## HISTORIC AND DESIGN REVIEW COMMISSION

October 03, 2018

**HDRC CASE NO:** 2018-486  
**ADDRESS:** 1018 BURNET ST  
**LEGAL DESCRIPTION:** NCB 1660 BLK 1 LOT 5  
**ZONING:** R-6, H  
**CITY COUNCIL DIST.:** 2  
**DISTRICT:** Dignowity Hill Historic District  
**APPLICANT:** Cory Johnson  
**OWNER:** Nicole Johnson  
**TYPE OF WORK:** Rear addition, replacement of windows, door, and columns, wood element repairs  
**APPLICATION RECEIVED:** September 17, 2018  
**60-DAY REVIEW:** November 16, 2018  
**REQUEST:**

**SHEET**

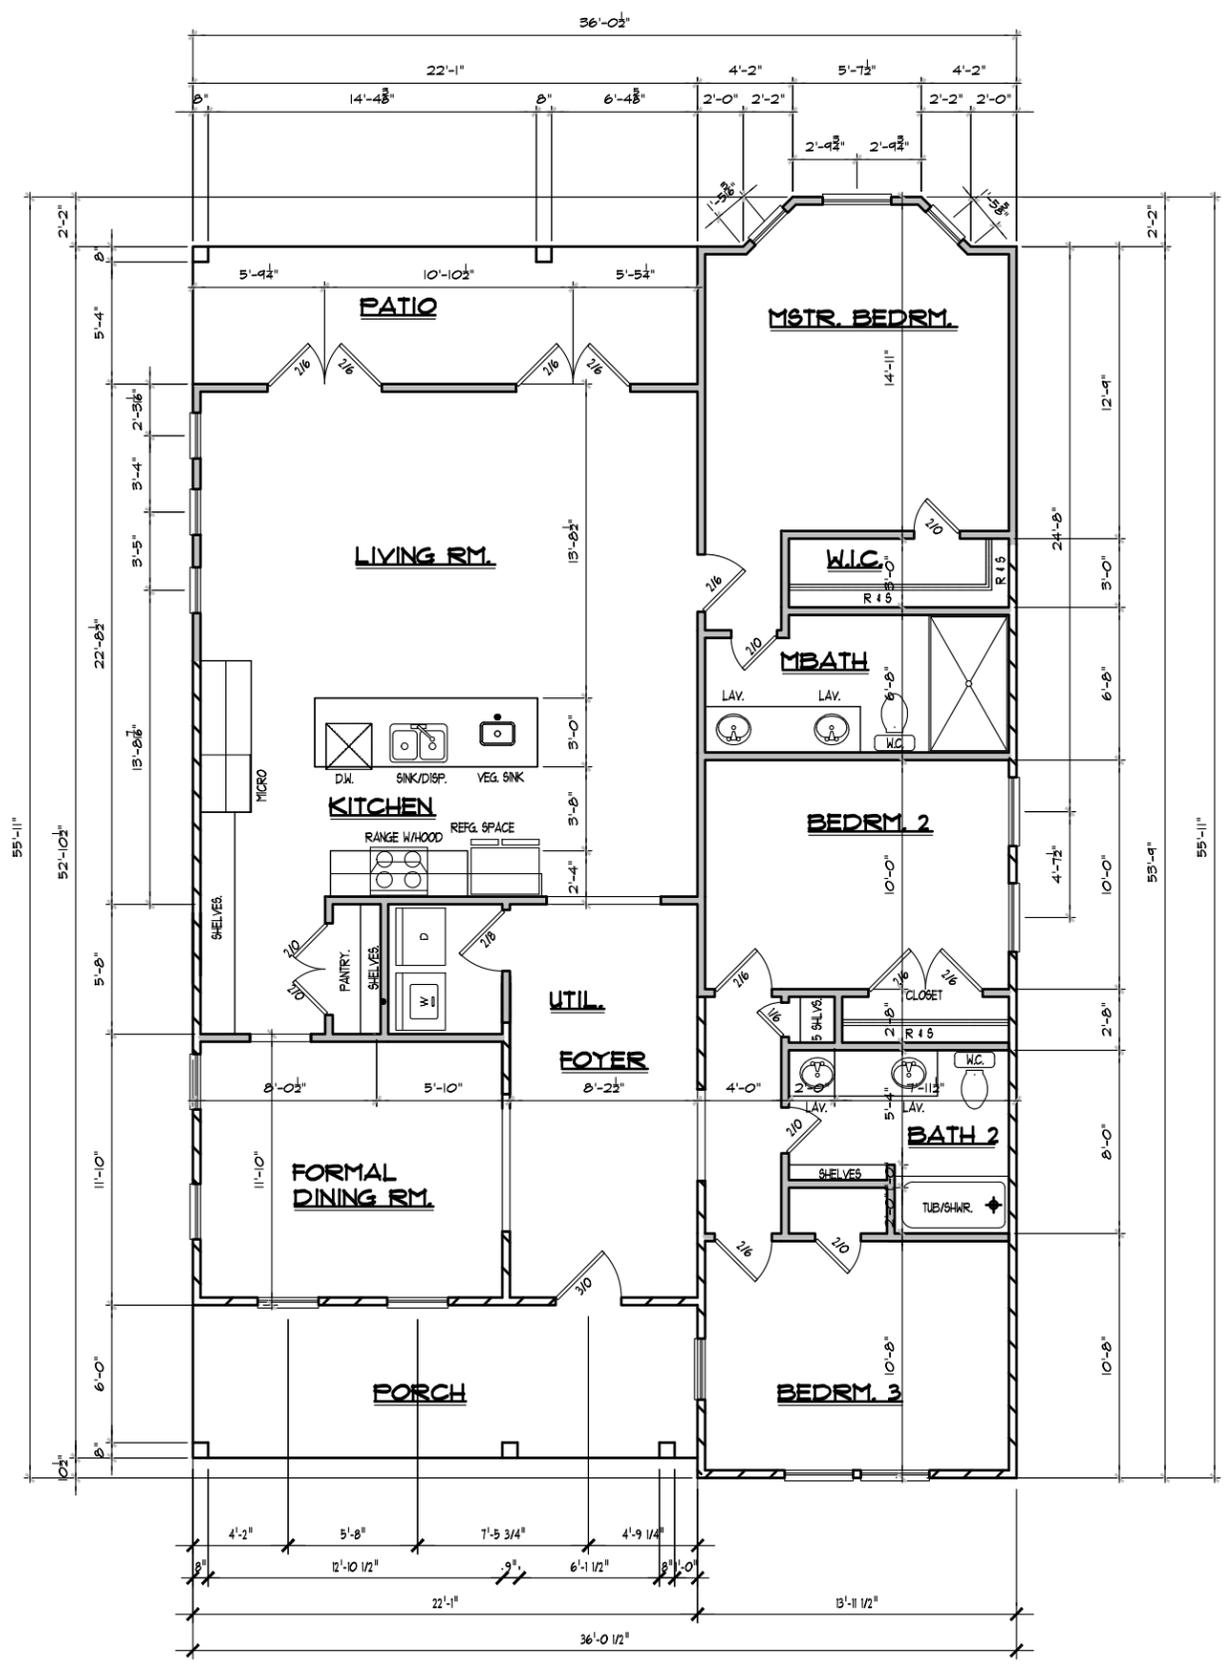
- c. **REAR ADDITION** – The Guidelines for Additions 1.A. states that additions should be sited to minimize visual impact from the public right of way, should be designed to be in keeping with the historic context of the block, should utilize a similar roof form and should feature a transition between the old and the new. The applicant has proposed for the addition to feature a matching ridgeline and wall plane with a vertical trim piece. The proposed addition also features a window bay, a covered deck, two sets of double-doors, and aluminum windows. Staff finds that the proposed addition and its details are not visible from the right of way and is generally consistent with the Guidelines, with the exception to exclude a subordinate ridge line and/or inset wall plane.

- f. **TRANSITION** – The applicant has proposed to use a vertical trim piece to distinguish between the original structure and the addition. Per the Guidelines for Additions 1.A.iv, additions should feature a setback or recessed area and a small change in detailing at the seam of the historic structure and new addition to provide a clear visual distinction between old and new building forms. A vertical trim piece may also be used to differentiate the proposed addition from the new construction; however, it should be installed in addition to the use of a subordinate ridge line and/or inset wall plane.

Item 1. Staff recommends approval of the rear addition based on finding c with the stipulation that it features a subordinate ridge line and inset wall plane in addition to the proposed vertical trim piece.

FLOOR PLAN

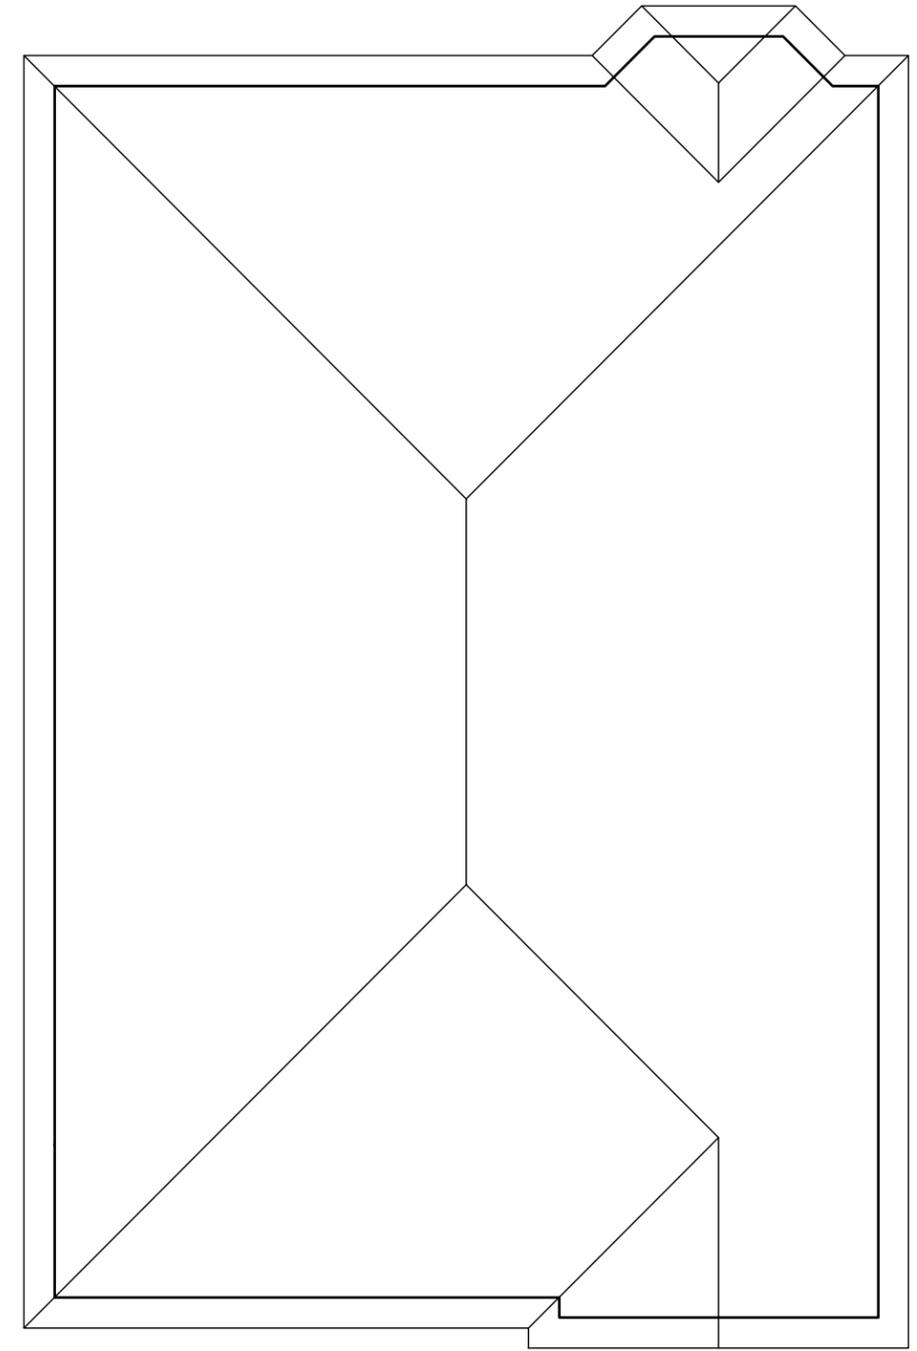
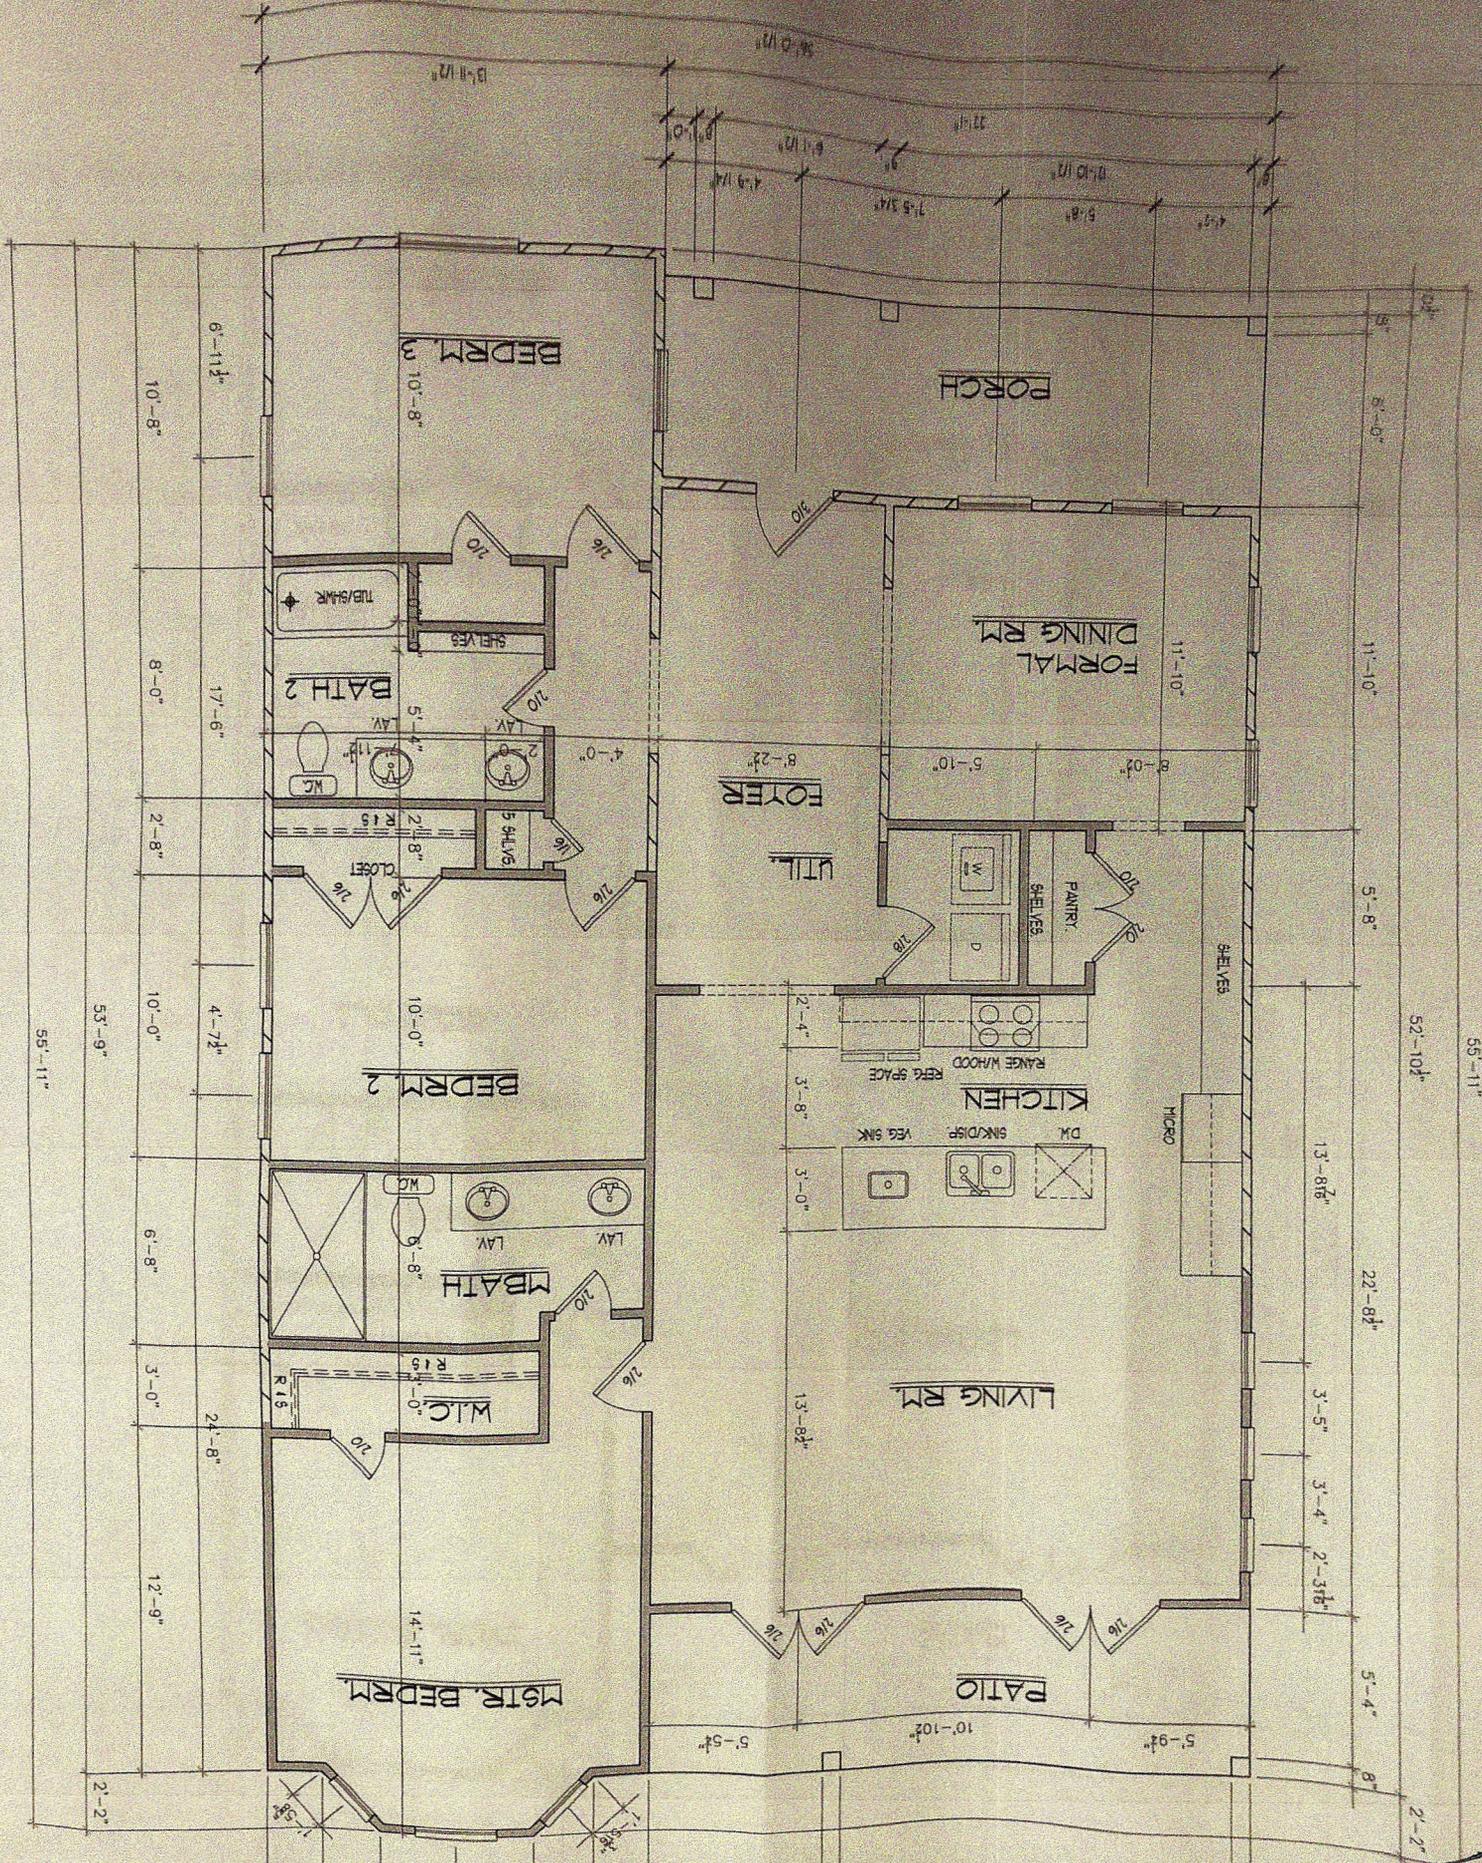
- d. **FOOTPRINT** – The applicant has proposed to construct a 792 square foot addition to the rear of the 1198 square foot primary historic structure. Staff finds the proposed footprint is consistent with Guidelines for Additions 1.B.iv. noting that additions should not double the size of the structure.

Front Door

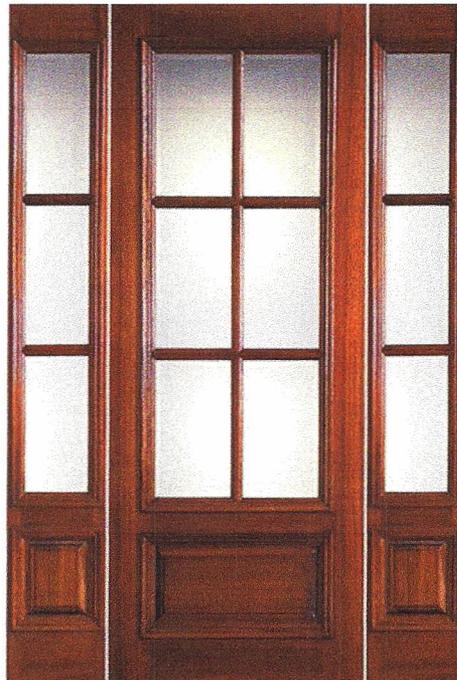
- o. DOOR REPLACEMENT – The applicant has proposed to replace the existing door and transom window with a new door featuring divided lights and sidelights. Per the Guidelines for Exterior Maintenance and Alterations 6.B.i, doors, hardware, fanlight, sidelights, pilasters, and entablatures in-kind when possible and when deteriorated beyond repair. Staff finds that proposed door modifications is inconsistent with the Guidelines and that the removed transom should be restored without the addition of new sidelights.

Item 6. Staff does not recommend approval to replace the existing door with transom for a new door with sidelights based on findings g.
